TOTALFLOW
Technical Bulletin 78

UCI2 Product Update Notice

Version 1.2, Revision AC (10 April, 2000)

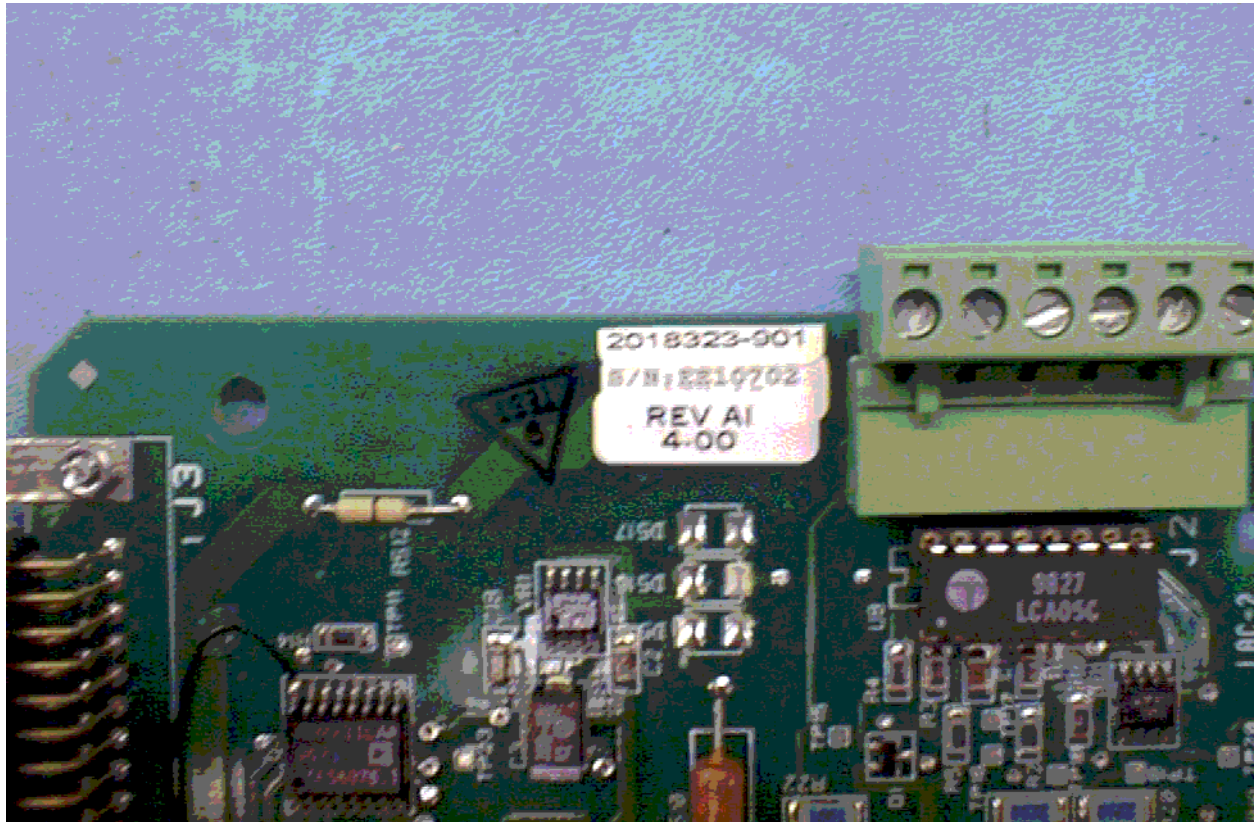
2400 baud modem version shown. Identifiers to distinguish this product from UCI, modem interface, or Datel modems are:

- Phone Jack connector
- Description tag (UCI2)
- Part # 2017379-???

To identify the enhancements, there is a serial number tag and revision On the electronic board (underneath the black top plate). This information will be located on a white tag near the edge of the board. The enhancements described in this bulletin will be on all boards with revision “AI” and higher boards (see close-up picture below). Any revisions from “AH” or below do not have the modem and RS-232 enhancements.

- Phone line will not hang up
- Modem will not answer an incoming phone call
- Modem answers but the Flow Computer will not respond
- Modem will not work with ground wire connected from UCI2 to Flow Computer enclosure
- RS-232 to RS-485 converter works intermittently

To ensure product reliability and customer satisfaction, ABB Totalflow would like to offer an exchange policy for any UCI2's with revision "AG" or lower. For a replacement call (800) 442-3097 and select the ABB Totalflow customer service option on your phone. You will need to have the specific part number of your UCI2 (2017379-001, -002, or -003) before calling. Our service staff will issue you a return authorization number and ship you a replacement. You will have 30 days to return the original UCI2. If the original UCI2 is not received within 30 days, you will be billed for a new unit.
